VICTORIA TRACE SUBDIVISION

APPLICATION NUMBER 15 DATE April 3, 2003
APPLICANT Victoria Trace Subdivision
REQUEST Subdivision

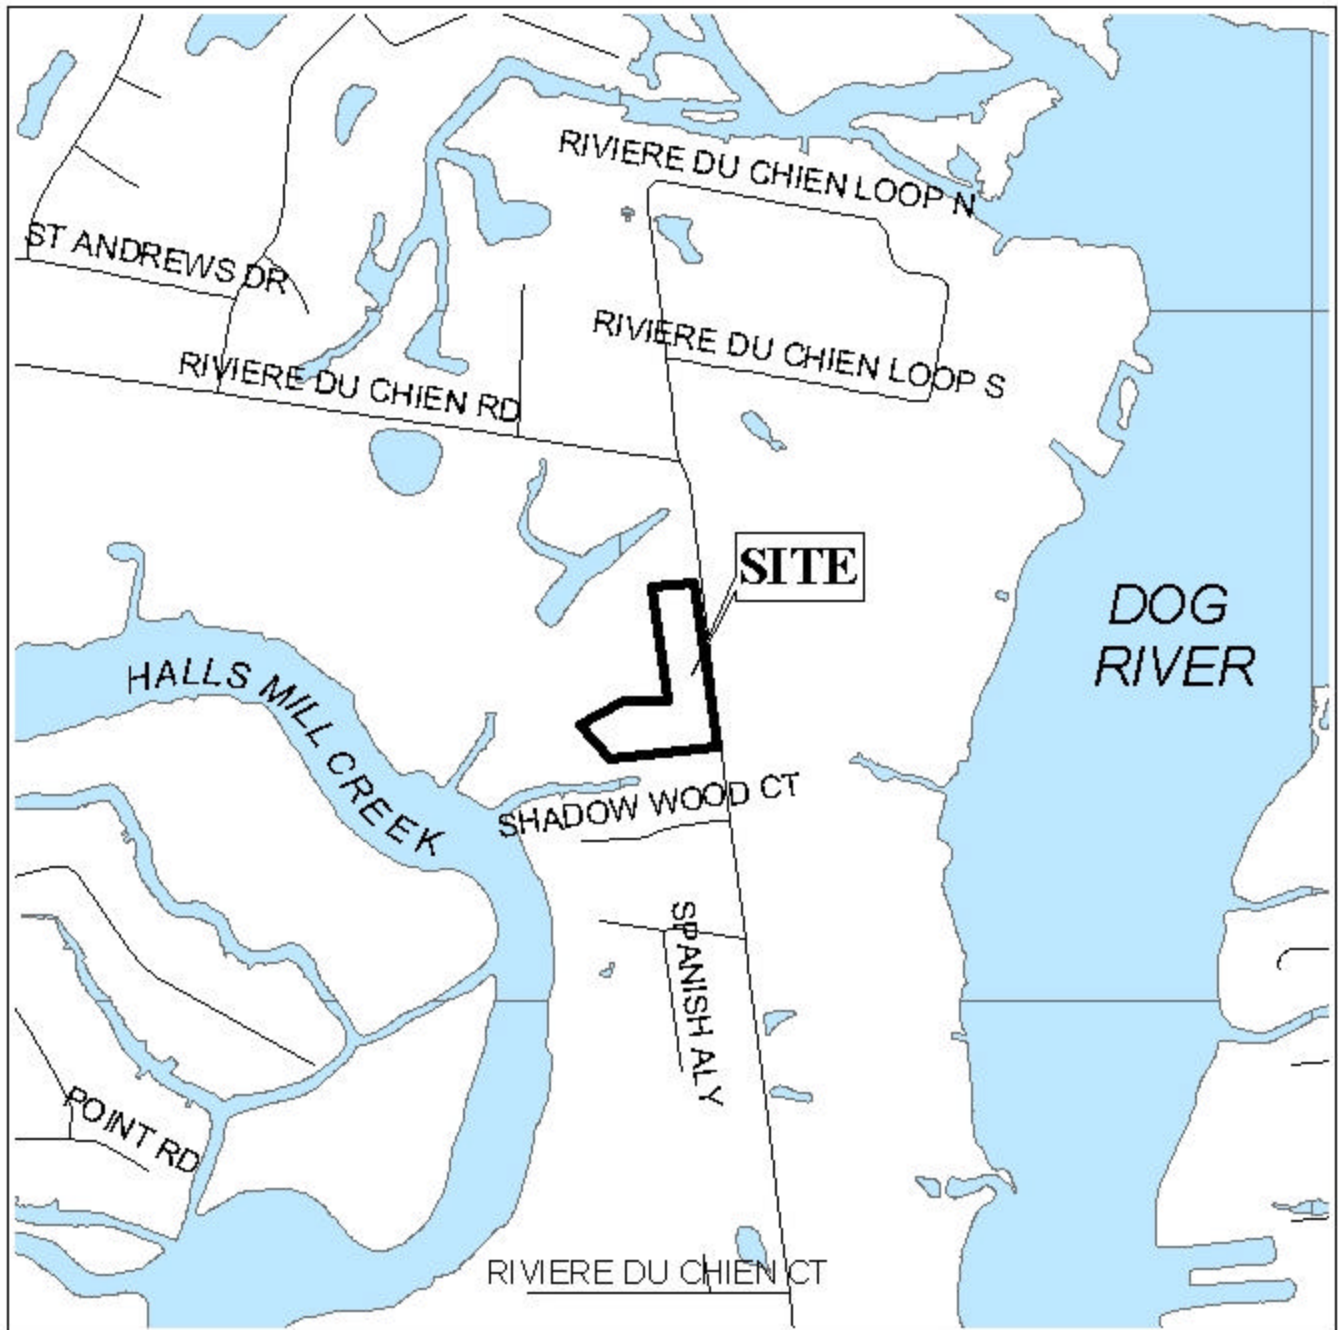
Engineering Comments: Common Area for stormwater detention not shown on plat. Full compliance with Stormwater Management Ordinance required, including creation of Property Owners Association to maintain common areas. Stormwater detention system to be completed prior to approval of final plat. Development of property must comply with all stormwater management and flood control ordinances. Any work performed in the right-of-way will require a right-of-way permit.

Traffic Engineering Comments: Driveway number, size, location and design to be approved by Traffic Engineering and conform to AASHTO standards.

Lots 5 and 6 exceed the maximum width to depth ratio as recommended by the Subdivision Regulations; therefore, a waiver of Section V.D.3. would be required.

The site is adjacent to Halls Mill Creek and as such the area may be considered environmentally sensitive; therefore, the approval of all applicable federal, state and local agencies would be required.

With modifications and a waiver of Section V.D.3., the plat will meet the minimum requirements of the Subdivision Regulations and is recommended for Tentative Approval subject to the following condition: 1) the approval of all applicable federal, state, and local agencies.
